BULLETIN NUMBER:
SB13-J-001A

**CRACKED TURBOCHARGER VACUUM SWITCHING VALVE (VSV) VACUUM HOSE
RELATED DTCs: P0299, P2263, P245B, P2413**

- 2011-2012MY Isuzu N-Series
Equipped with 3.0L 4JJ1 Diesel Engine

Figure 1 – Broken Vacuum Hose Location

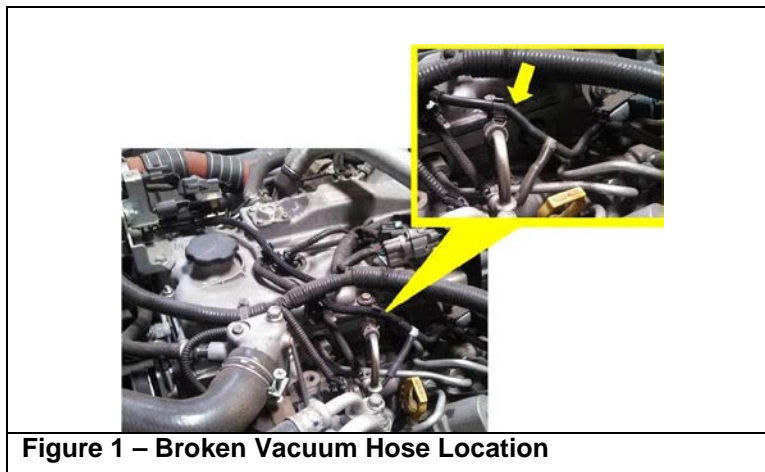
The vacuum hose for the Turbocharger Vacuum Switching Valve (VSV) may crack at the clip location shown in Figure 1.

NOTE: Do not use bulk hose material for the countermeasure. The new hose assembly has been redesigned to offer additional reinforcement.

If the above cause is found, follow the service procedure in this bulletin to replace the vacuum hose assembly.

Figure 2 – Removal of Vacuum Hose

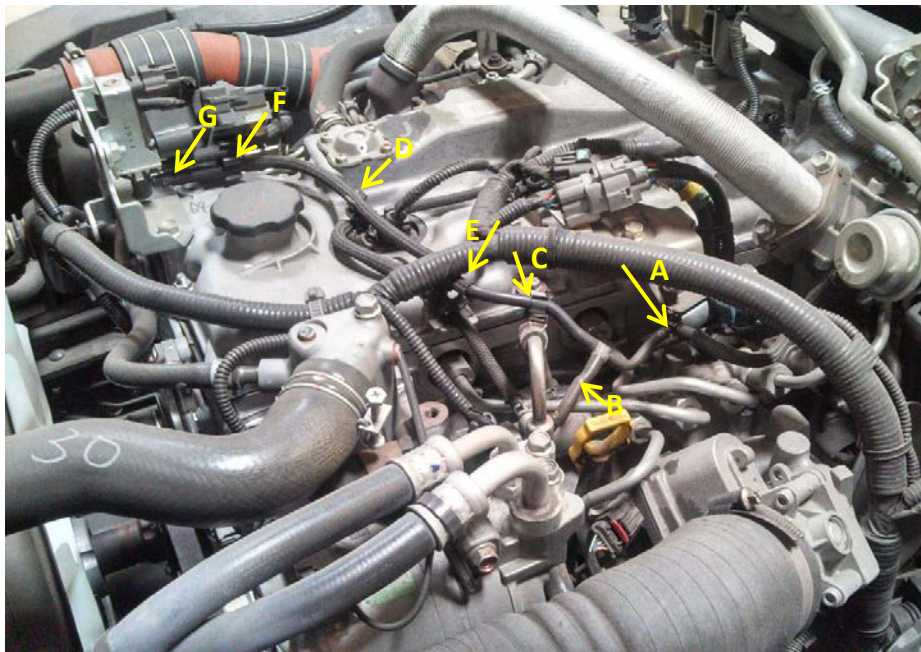
1. Remove the vacuum hose assembly below in the following order:
 - a. Vacuum Supply Pipe
 - b. EGR Bypass Vacuum Switch Valve (VSV)
 - c. Retaining Clip
 - d. Hose with Retaining Clip
 - e. Clip
 - f. Turbo Charger Actuator
 - g. Turbo Charger VSV (2 hoses)

2. Install the replacement hose in the following order:

a. Vacuum Supply Pipe

NOTE: To help ease installation, spray the hose with soapy water.

b. EGR Bypass VSV

c. Retaining Clip

d. Hose with Retaining Clip

e. Clip

f. Turbo Charger Actuator

g. Turbo Charger VSV (2 hoses)
